From: "Stillwell, Daniel" <dwstillwell@STPEGS.COM>
To: "Mark Tonacci" <MET@nrc.gov>
Date: 11/15/2007 3:54:28 PM
Subject: Additional Information on Main Cooling Reservoir Breach
cc: "David Dujka" <dldujka@STPEGS.COM>,"Gregory T Gibson" <gtgibson@STPEGS.COM>,"John T Conly" <jtconly@STPEGS.COM>,"Steven Thomas" <sethomas@STPEGS.COM>,"William Mookhoek" <wemookhoek@STPEGS.COM>

APPENDIX J
REEVALUATION OF THE COMPLETED
MAIN COOLING RESERVOIR

The NRC staff has completed its review of Houston Lighting & Power Company's (HL&P) submittals of February 22, 1993, October 1, 1993, March 28, 1994, and June 20, 1994, on the performance of the main cooling reservoir (MCR) and the essential cooling pond (ECP) at South Texas Project (STP). The submittals are in response to NRC's Safety Evaluation Report related to operation of STP, Supplement 2, Section 2.5.7, "Reevaluation of Completed Main Cooling Reservoir," and the NRC's requests for additional information.

Figure 3 Typical cross-section for analysis
Source: Provided at meeting between NRC and applicant, Bethesda, Maryland, April 2, 1985

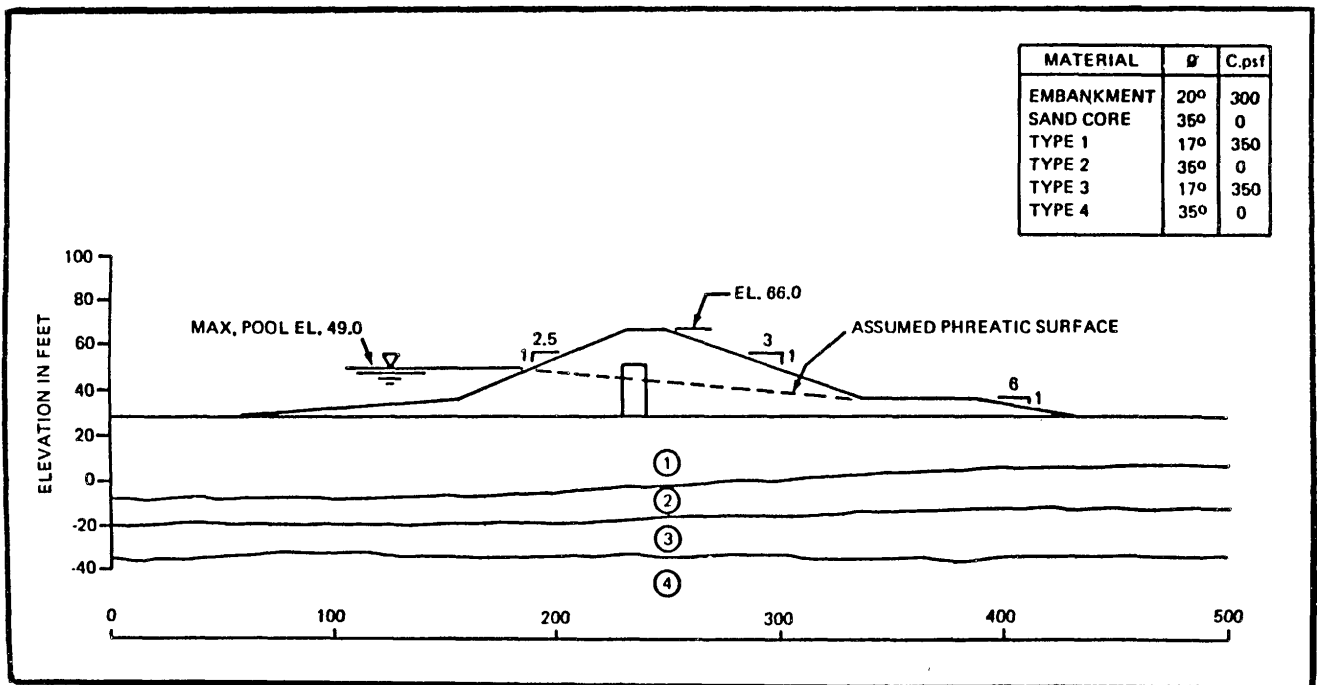
Stability analyses were performed based on strength parameters established for the initial design. Additional field investigations (see Figure 2) and soil testing were performed to verify the original design parameters. A total of 48 borings were drilled to obtain undisturbed samples and to perform standard penetration tests. Laboratory testing included consolidation tests and triaxial and direct shear strength tests. These tests confirmed that strength parameters used in the stability analyses are conservative. Results of the field and laboratory programs are presented by Harza Engineering Company (Vols. 2 and 3, 1984). The stability of the embankment was studied for steady-state seepage, rapid drawdown, and seismic conditions. These analyses are presented in detail by Harza Engineering Company (Vol. 1, 1984) and summarized in Table 1. A typical embankment cross-section with selected material strengths is shown on Figure 3.

Figure 4 Seismic stability evaluation
 Source: Provided at meeting between NRC and applicant, Bethesda, Maryland, April 2, 1985

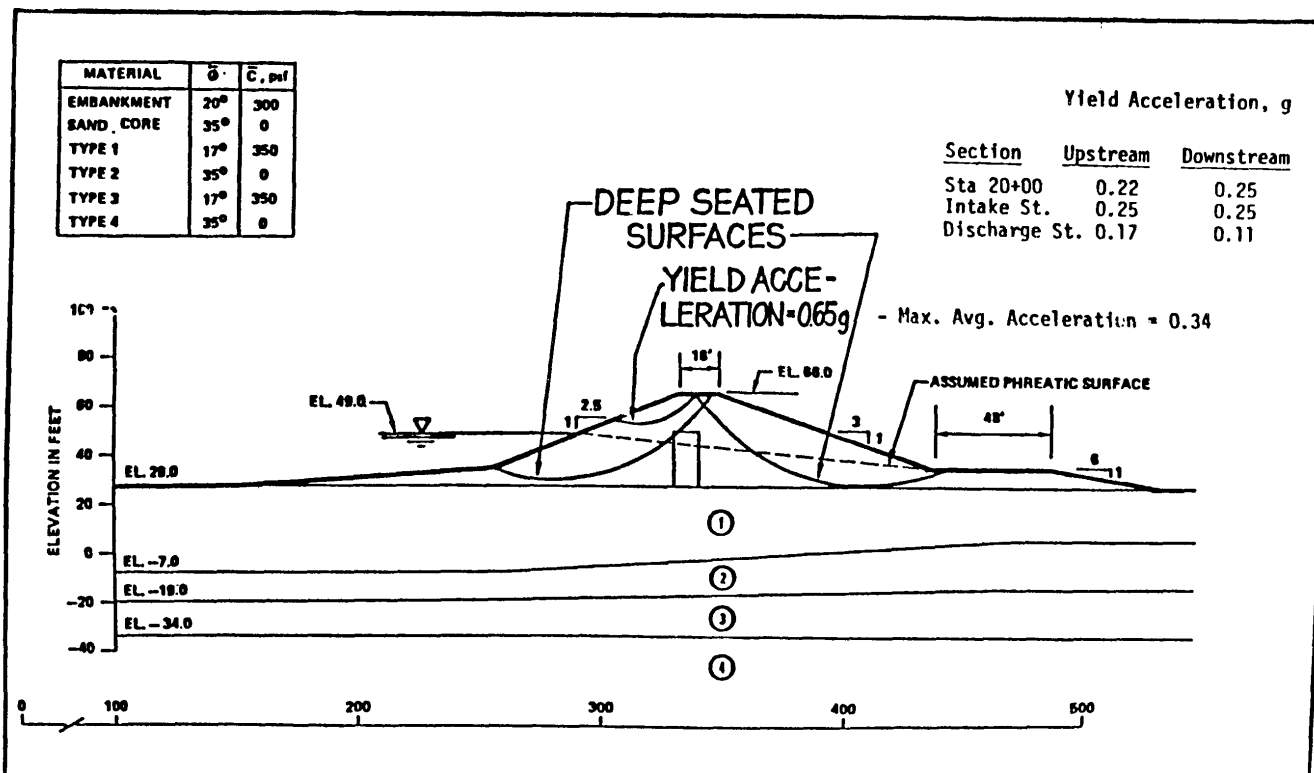
Because the project is located in a very low seismicity zone with the clay embankment founded on clays and medium dense to dense sands, a Newmark-type displacement analysis was performed. Also, a liquefaction potential analysis was performed for the embankment between stations 42+50 and 72+50 where low-blow-count sandy material was encountered. Results of the displacement analyses are presented on Figure 4 and show that permanent deformations will not occur because the yield accelerations are much greater than the safe shutdown earthquake (SSE)-induced accelerations. Also, clay embankments on clay or dense sand have successfully withstood earthquake accelerations much higher than the SSE for the South Texas plant with no significant effects (Seed, Makdisi, and DeAlba, 1978). Results of the liquefaction potential analysis are shown on Figure 5 with the cyclic strength determined for average corrected standard penetration values and the cyclic stress determined from a response spectrum analysis corrected for confinement pressures (depth) estimated for nonlevel ground near the embankment.

Figure 6 Surface slide
Source: HL&P

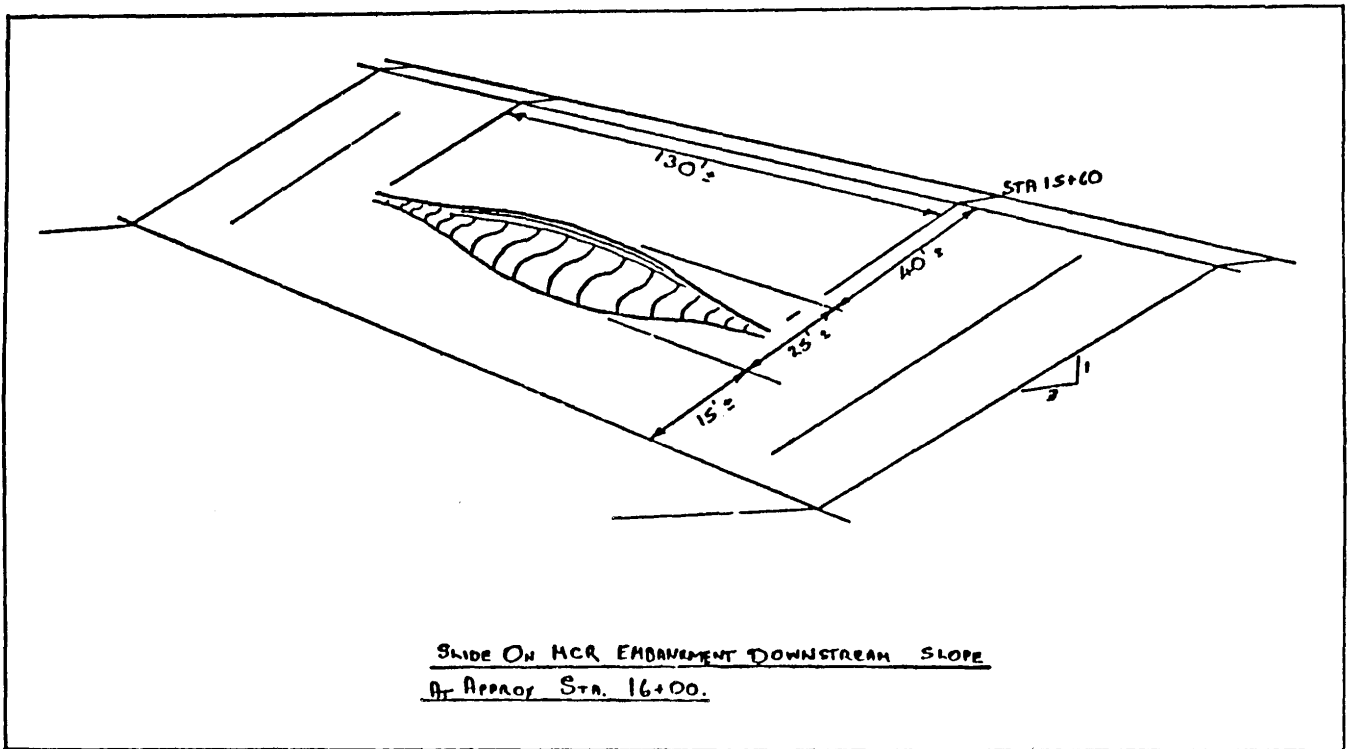
In early 1985, a surface or "skin" slide occurred on the downstream face of the embankment. The approximate location and configuration of the slide are shown on Figure 6. The embankment soils are highly plastic; such soils tend to shrink and swell with alternating drying and wetting cycles. Surface slides are to be expected in these type materials; however, they do not affect the overall stability of the embankment. The staff concurs with this assessment of the effect of surface slides.

Figure 7 Penetration through the embankment
 Source: Provided at meeting between NRC and applicant,
 Bethesda, Maryland, April 2, 1985

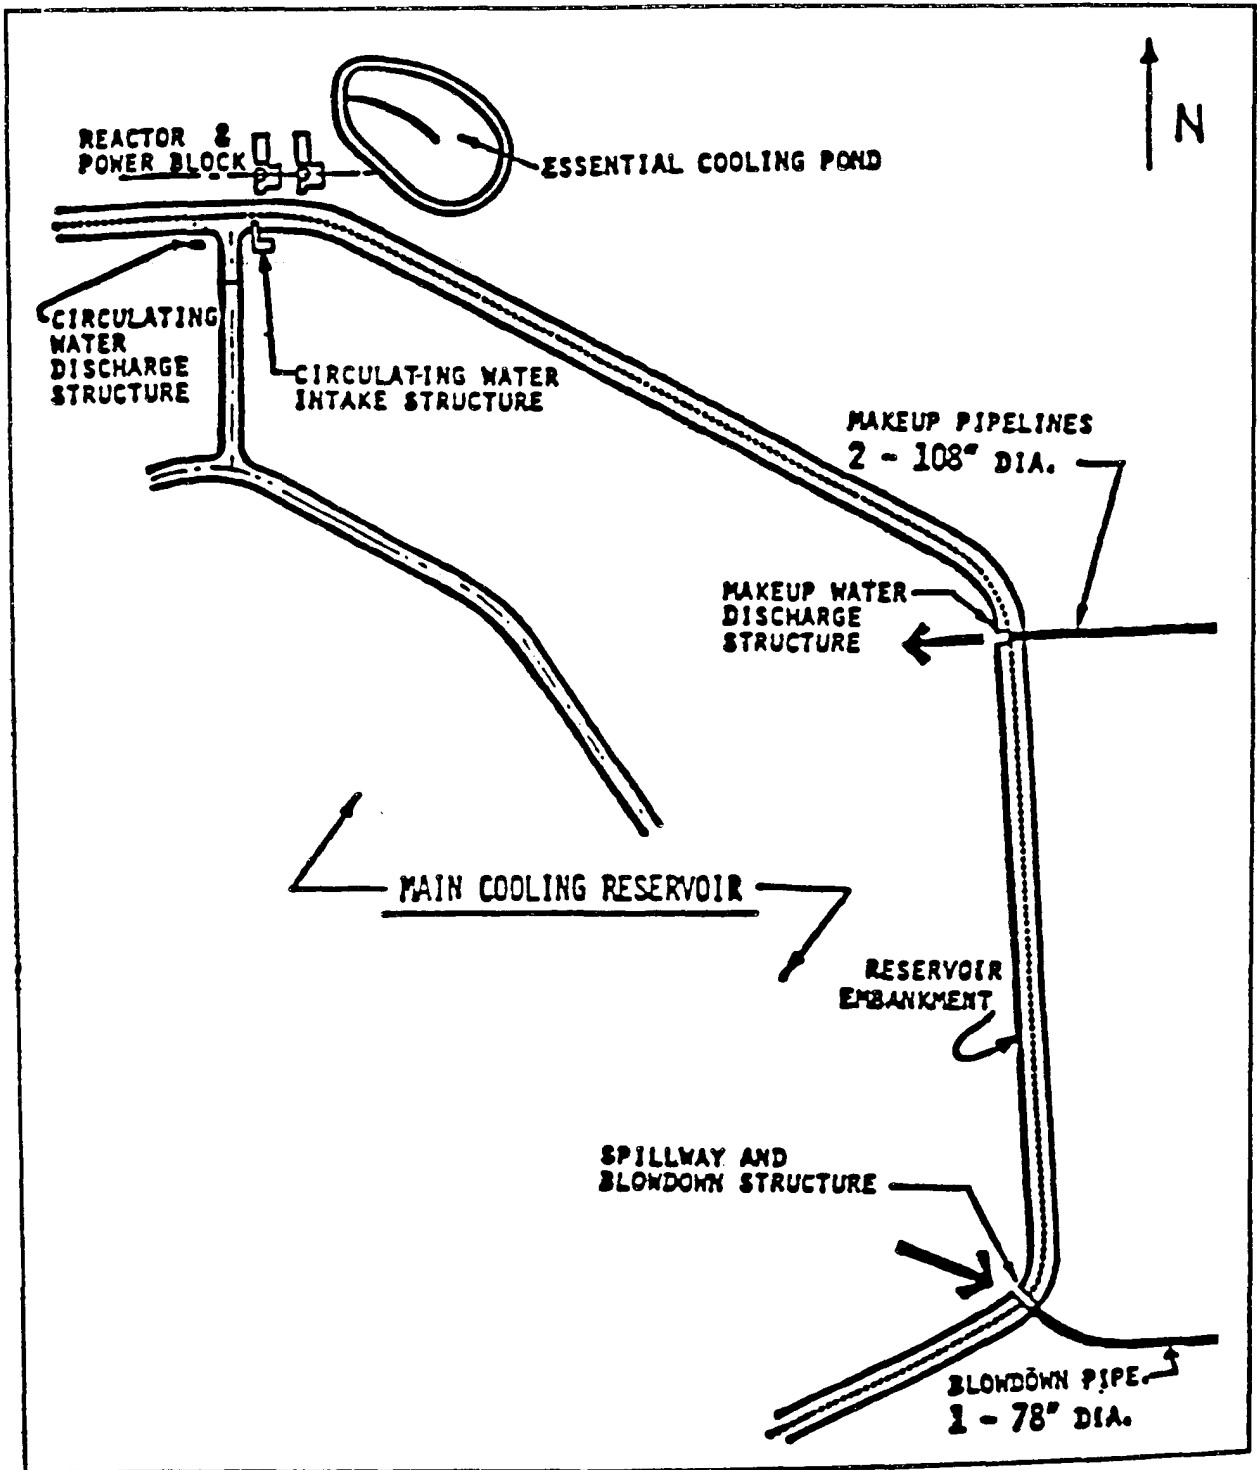
There are a number of pipe and structural penetrations through the existing embankment as shown on Figure 7. Only the circulating water intake and discharge pipes are located in the section of the embankment opposite the power block. These pipes, shown on Figure 8, consist of eight 96-inch-diameter pipes for the intake that tap into four 138-inch-diameter pipes near the toe berm, and four 138-inch-diameter pipes of the same type for the discharge. The pipes that penetrate the embankment have bell and spigot joints with rubber gaskets and are embedded in sand and surrounded by embankment material. Some joints were welded at bends to provide thrust restraint, and some were harnessed to permit joint rotation. Major concerns related to these pipes included a lack of inspectability and lack of watertightness of joints that could open, causing leakage and subsequent embankment failure. Remedial measures to alleviate these concerns are currently in progress (see Figure 9). Measures consist of removing the existing pipes, installing new concrete pipes at the crest and slopes in concrete chutes to provide erosion protection and inspectability of joints, and installing additional piezometers along the existing pipes at the berm to detect any leakage that might develop.

In addition to the above modifications, individual joint liners for makeup and blowdown pipes and chemical grout barriers for the makeup structure and spillway are being implemented to improve the reliability of the reservoir embankment.
